SAFETY RECALL

Number
SC0411

JOST Fifth Wheel Inspection

AN

Outboard Slider Side-to-Side Clearance Inspection Procedure

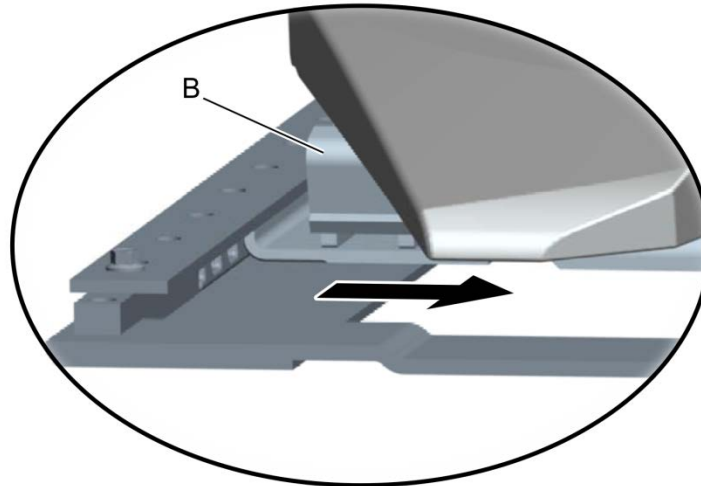
1. Use a pry-bar to force the top plate bracket (B) over to one side.

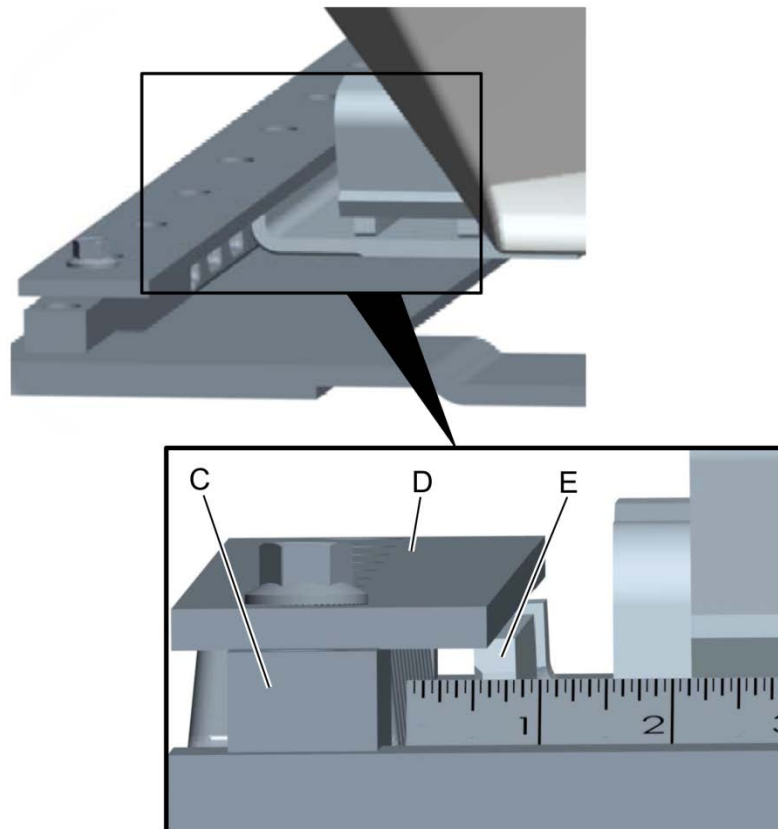
2. Place a ruler or tape measure under the cover (D) to measure the gap between the rack (C) and bracket (E). If there is a gap of 12.7mm (0.5 in) or more, the inspected JOST fifth wheel is the unit in question and should be immediately replaced.
